STAFF REPORT: 10/09/2024 REGULAR MEETING

APPLICATION NUMBER: HDC2024-00542

ADDRESS: 3960 (3966) W. 7 MILE RD.

SCOPE: REPLACE DOORS, WINDOWS AND SIDING

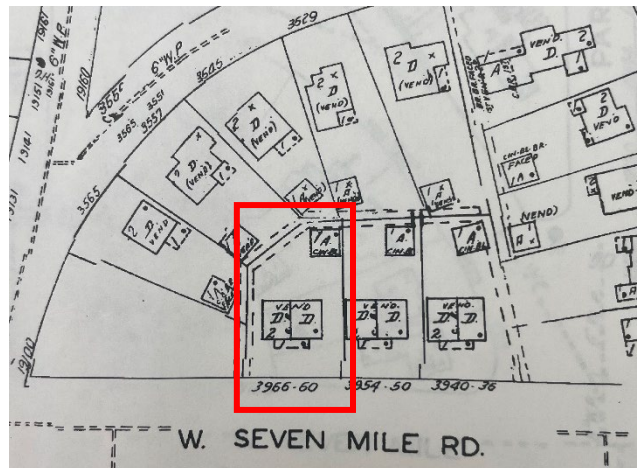
- Remove all wood lap siding, front and rear.
- Remove all wood soffits and fascia, front and rear.
- Install 6" Hardie lap siding with underlay of Tyvek house wrap.
- Install aluminum fascia and soffits with wood grain finish.
- Install white aluminum wrap on corners.
- Prime and paint all new siding white.

- Staff has the opinion that the replacement of the wood clapboard siding, soffits, fascia and trim with Hardie board and aluminum trim is inappropriate and does not meet National Park Service Standards, which states that materials shall be repaired and if not repairable, replaced with matching materials.
